The BULLETIN OF THE BEAUX-ARTS INSTITUTE OF DESIGN

THE BULLETIN OF THE
BEAUX-ARTS INSTITUTE OF DESIGN
AUGUST 1950 VOL. XXVI NUMBER FIVE SCHOOL YEAR 1949-1950

CLASS A PROBLEM IV—A CHILDREN'S TUBERCULAR SANATORIUM

PROF. V.
A. S. BERNSTEIN
JOSEPH S. CLEMENTO
UNIVERSITY OF NOTRE DAME
98

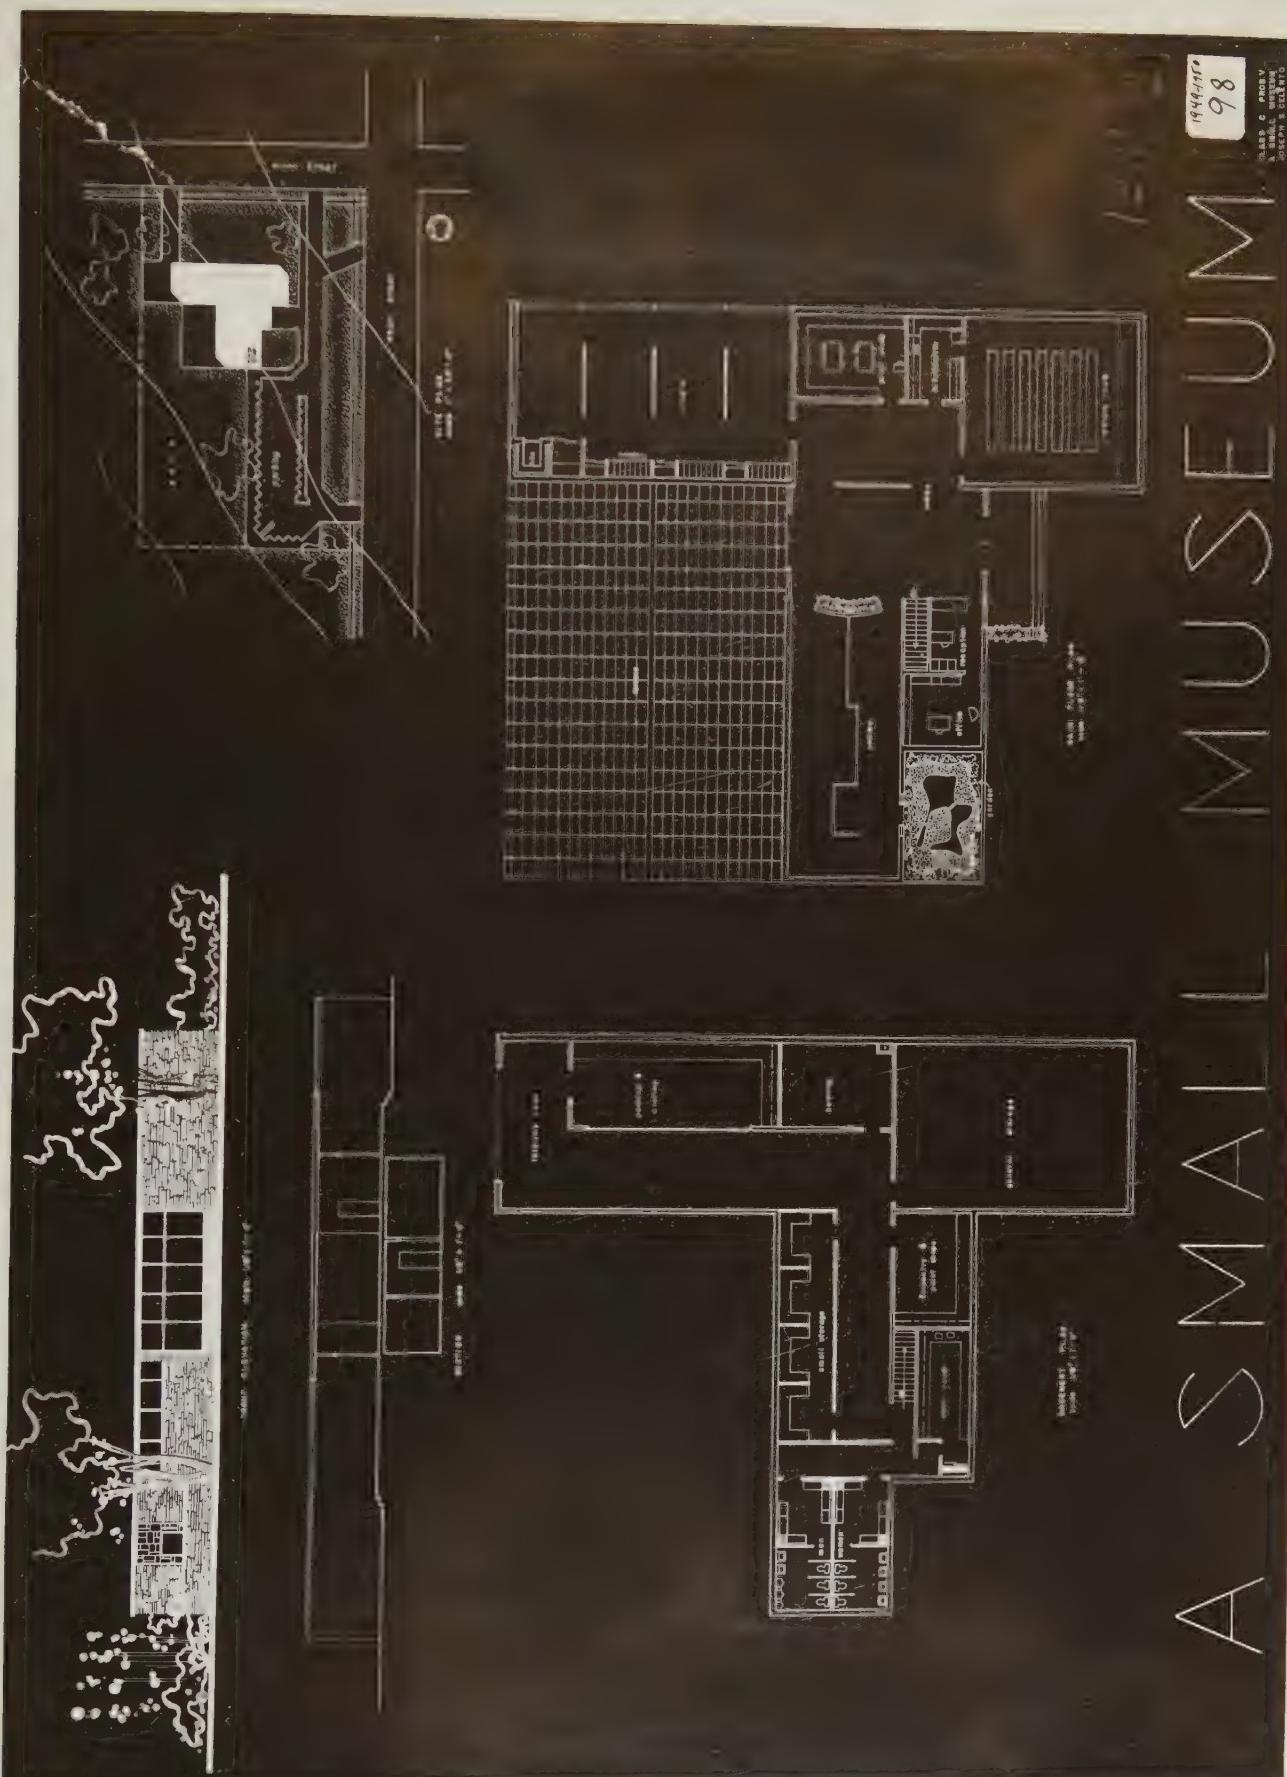
THE PROBLEM OF MR. J.S. CELENTO OF UNIVERSITY OF NOTRE DAME RECEIVED THE HIGHEST AWARD OF FIRST MENTIONED PLACED, BECAUSE OF THE EXCELLENT PLAN, DIGNIFIED, ATTRACTIVE AND STRAIGHT FORWARD ELEVATION, AND GOOD USE OF THE SITE.

J.C. CORPUS ET AL.
OKLAHOMA A&M
COLLEGE OF ARTS &
CRAFTS CENTER

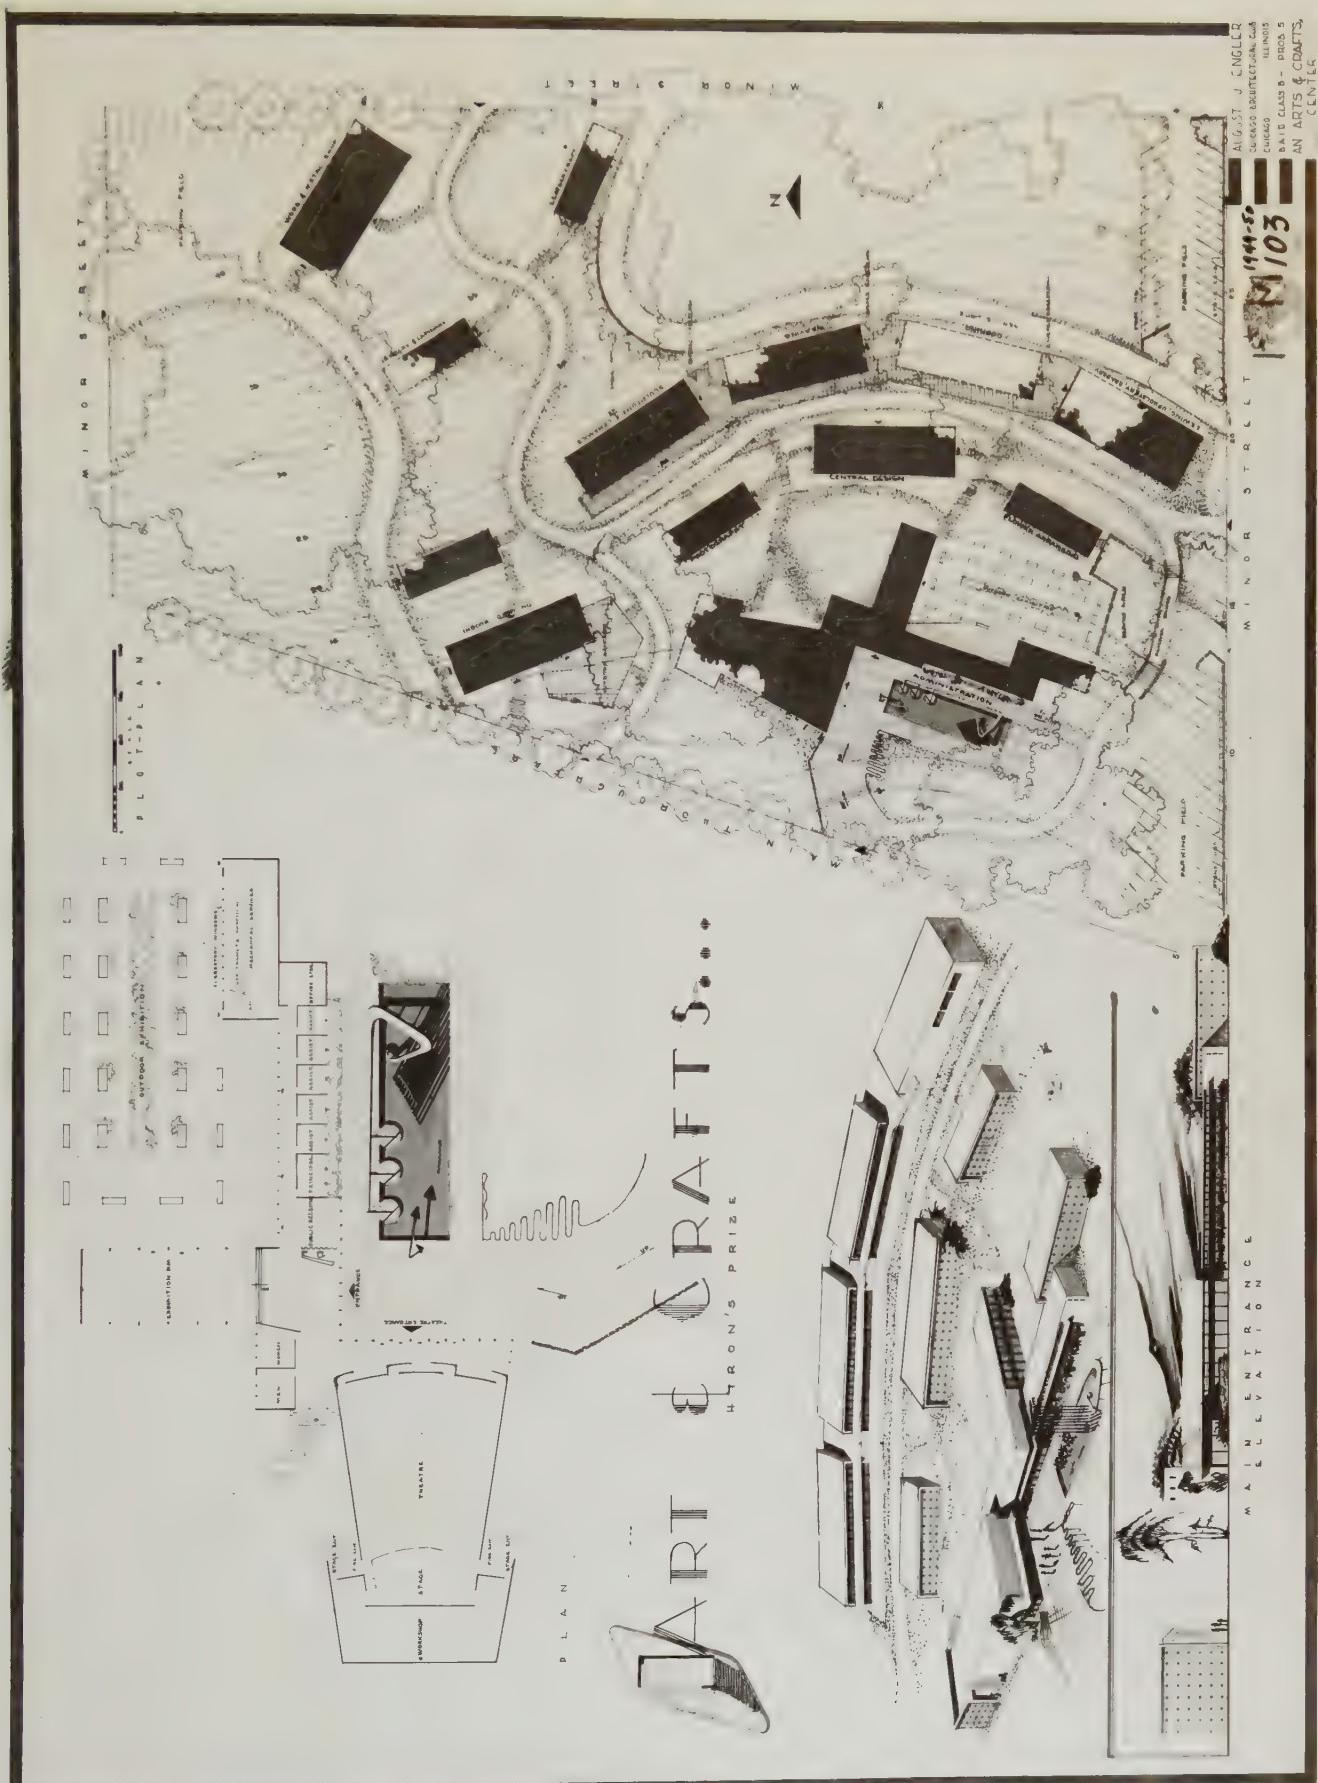
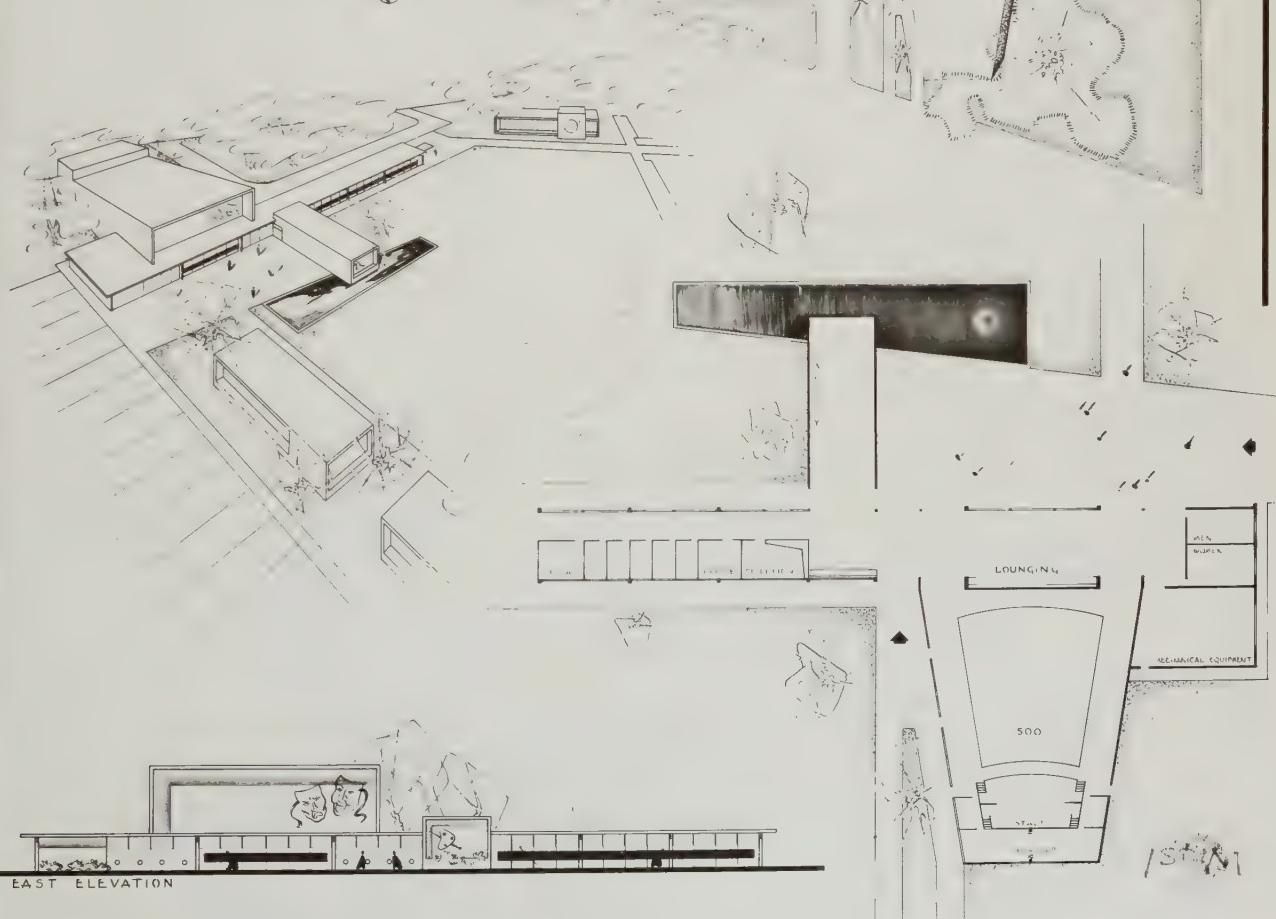
IN CLOSING IT MAY BE MENTIONED THAT THE PRIZE WINNER, THE DESIGN BY J.C. COPPEDGE, OKLAHOMA AGRIC. & MECH. COLLEGE, WAS SELECTED BY UNANIMOUS VOTE. A DIGNIFIED RENDERING, A GOOD PLOT PLAN,recognition of the land contours in placing the several buildings to best advantage together with a well solved administration building, all entered into the choice of the winner for the HIRONS PRIZE.
